PG&E Letter DCL-20-092

Diablo Canyon Units 1 and 2  
Docket No. 50-275, OL-DPR-80  
Docket No. 50-323, OL-DPR-82  
License Amendment Request 20-03  
Proposed Technical Specifications and Revised License Conditions for the  
Permanently Defueled Condition

Subject: Proposed Changes to Licenses and Technical Specifications to Reflect a Permanently Defueled Condition

Figure 2.1.1-4  
REACTOR CORE SAFETY LIMIT

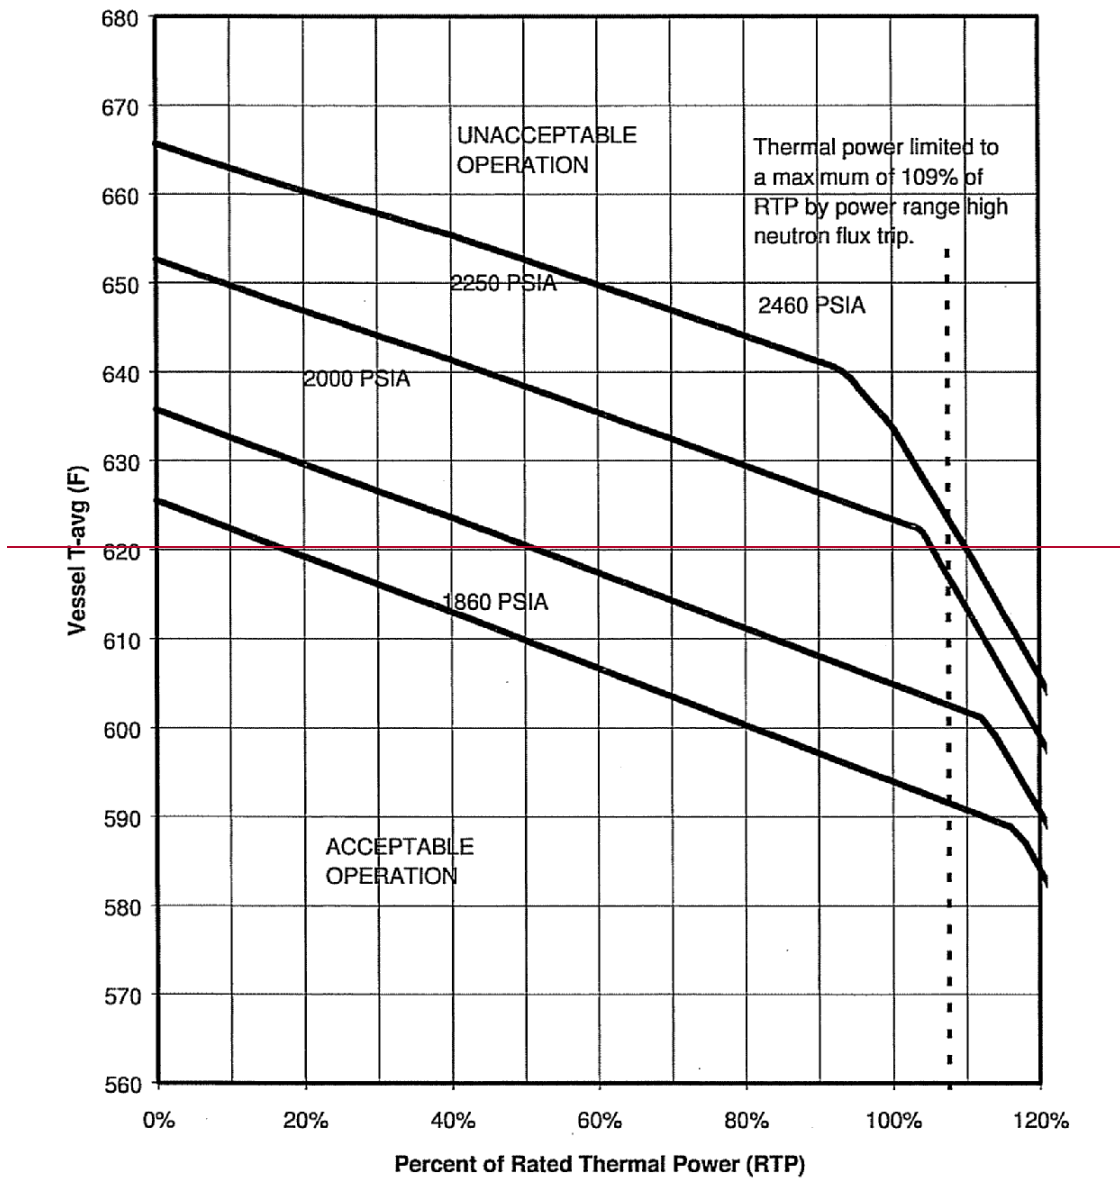
TS 2.2, SL Violations	TS 2.2.1 and 2.2.2 describe actions to take if TS 2.1.1 or 2.1.2 is violated. Because TS 2.1.1 and 2.1.2 are being proposed for deletion, TS 2.2.1 and 2.2.2 are no longer required and are proposed for deletion.
Figure 2.1.1-1, Reactor Core Safety Limit	<p>Figure 2.1.1-1 provides the acceptable values for thermal power, RCS highest loop average temperature, and pressurizer pressure to meet the requirements of TS 2.1.1.</p> <p>The limits provided in Figure 2.1.1-1 prevent overheating of the fuel and cladding, as well as possible cladding perforation that would result in the release of fission products to the reactor coolant. These limits are applicable is MODES 1 and 2.</p> <p>Pursuant to 10 CFR 50.82(a)(2), once PG&amp;E docket the certifications required by 10 CFR 50.82(a)(1), the licenses for DCP Units 1 and 2 will no longer authorize operation of the reactors or placement or retention of fuel in the reactor vessels. Since the SLs apply to an operating reactor, they have no function in the permanently defueled condition. Therefore, this figure is proposed for deletion.</p>

3.7.17 Spent Fuel Assembly Storage

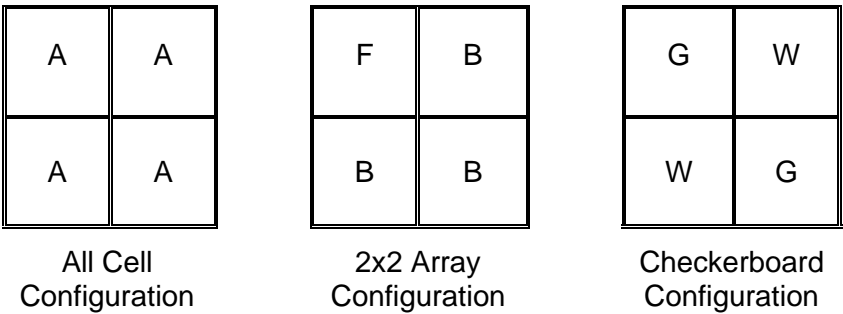
TS 3.7.17 – This TS places restrictions on the placement of fuel assemblies within the SFP, to ensure the  $k_{eff}$  of the spent fuel storage pool will always remain less than or equal to 0.95 at a 95 percent probability, 95 percent confidence level, for a postulated reactivity insertion accident or a boron dilution event. This TS is applicable when any fuel assembly is stored in the SFP and will be retained in the PDTs (including Figures 3.7.17-1, 3.7.17-2, and 3.7.17-3) with the following changes. TS 3.7.17.b, 3.7.17.c, and the associated Figure 3.7.17-4 are being proposed for deletion. TS 3.7.17.b, 3.7.17.c, and the associated Figure 3.7.17-4 were added to the DCCP TS via License Amendments 183 and 185 approved by the NRC on November 21, 2005 (Reference 23). These amendments allowed the installation and use of a temporary cask pit spent fuel storage rack for Units 1 and 2 during Cycles 14-16. This TS LCO is historical in nature and will not be applicable during decommissioning. Therefore, TS 3.7.17.b, 3.7.17.c, and the associated Figure 3.7.17-4 are proposed for deletion.

- LCO 3.7.17      Fuel assembly storage in the spent fuel pool shall be maintained such that:
- a. In the permanent spent fuel storage racks any four cells shall be in a configuration as shown in Figure 3.7.17-1, ~~and~~
  - ~~b. In the cask pit storage rack, for Cycles 14 – 16, the fuel assemblies shall have:~~
    - ~~1. An initial enrichment  $\leq 4.1$  wt% U-235;~~
    - ~~2. A discharge burnup in the “acceptable” region of Figure 3.7.17-4; and~~
    - ~~3. A minimum decay time of 10 years since being discharged from the reactor.~~
  - ~~c. The total combined spent fuel pool capacity in the permanent and cask pit storage racks, for Cycles 14 – 16, is limited to no more than 1433 irradiated fuel assemblies. This limit does not apply for an emergency core offload.~~

- LCO 3.7.17            Fuel assembly storage in the spent fuel pool shall be maintained such that:
- a.    In the permanent spent fuel storage racks any four cells shall be in a configuration as shown in Figure 3.7.17-1.

FIGURE 3.7.17-1  
ALLOWABLE STORAGE CONFIGURATIONS  
(ALL CELL, 2X2 ARRAY, CHECKERBOARD)  
FOR THE PERMANENT SPENT FUEL POOL STORAGE RACKS

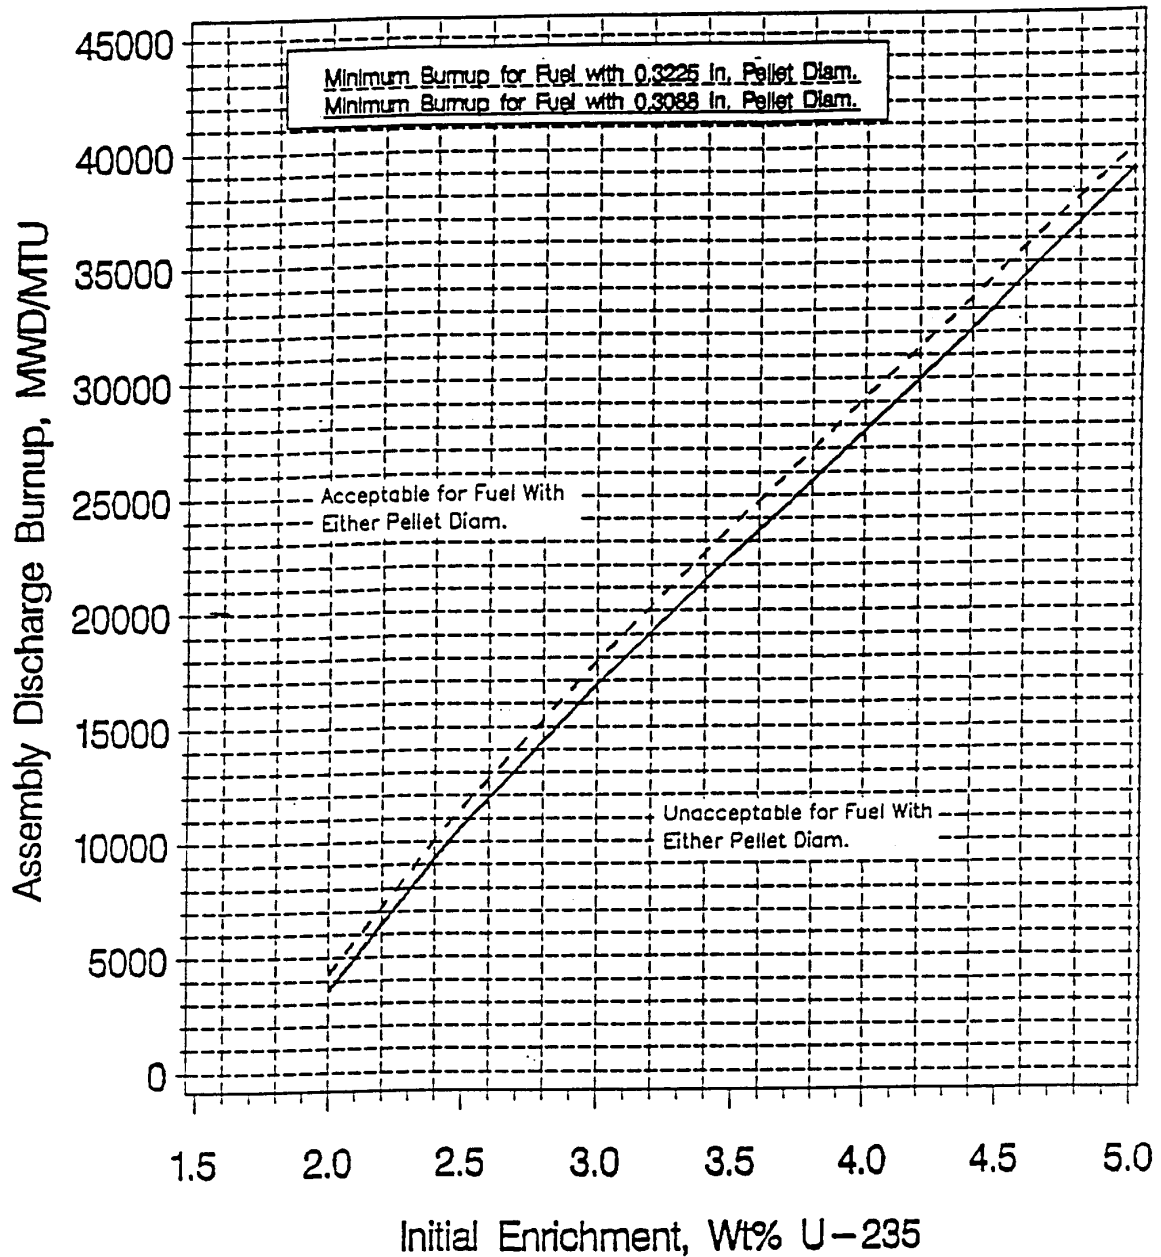
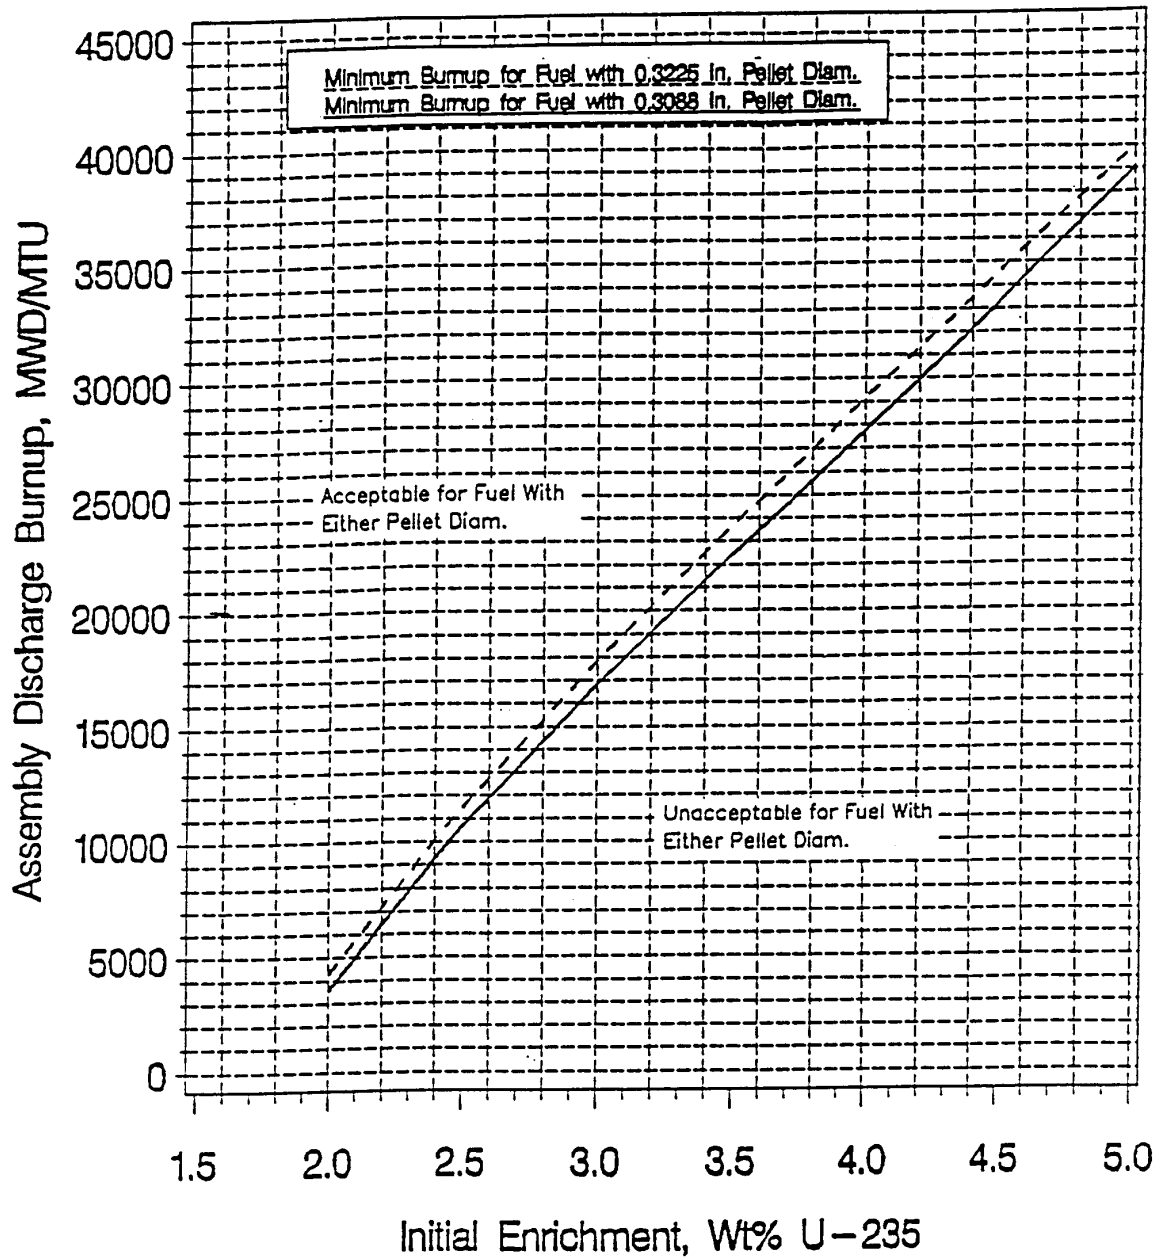
- e. Fuel assemblies with a discharge burnup in the "acceptable" region of Figure 3.7.17-2 for the all cell configuration as shown in Figure 3.7.17-1;
- f. Fuel assemblies with a discharge burnup in the "acceptable" region of Figure 3.7.17-3 for the 2x2 array configuration as shown in Figure 3.7.17-1.

- d. A nominal 11 inch center to center distance between fuel assemblies placed in the fuel storage racks;
  - e. Fuel assemblies with a discharge burnup in the "acceptable" region of Figure 3.7.17-2 for the all cell configuration as shown in Figure 3.7.17-1;

- f. Fuel assemblies with a discharge burnup in the "acceptable" region of Figure 3.7.17-3 for the 2x2 array configuration as shown in Figure 3.7.17-1.
